# Technical Note

Project: A29 Realignment Scheme – Phase 1

Subject: Noise Barrier Design Queries

Figure 1 - Cross Section through Pinch Point

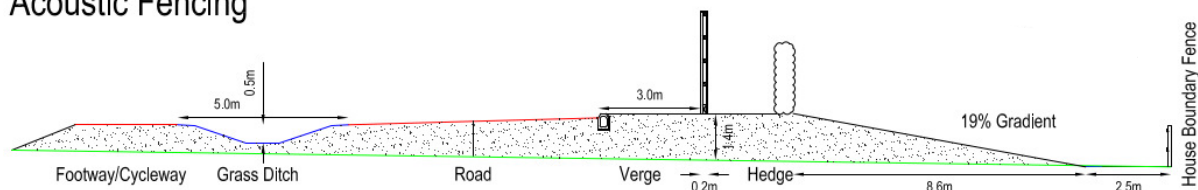
- 1. A short design note setting-out how the location of the fence in relation to the new road has been arrived at.*
- 2. Details of maintenance access strategy for the fence (including measures for preventing unauthorised access behind it).*

- Minimum space requirements so to provide suitable verge width in front of the acoustic barrier to enable the construction team to be able to physically fit in ADS signage, drainage facilities, etc.
- The location of attenuation pond 3 is subject to space constraints due to the vertical alignment design of the road and providing a suitable drainage solution;
- The “pinch point” that exists at approximately carriageway chainage 1020m, where the carriageway alignment is closest to an existing property within Murrell Gardens. Given that the carriageway and acoustic barrier are on embankment, sufficient room is required behind the barrier so to “fit” the embankment within the limits of the site, whilst still providing/maintaining access at the toe of the new embankment for residents within Murrell Gardens who have rights to access. See cross section at this pinch point below.

Between chainage 765m – 889m a 5m offset was required due to the positioning of a drainage swale between the carriageway and the acoustic barrier.
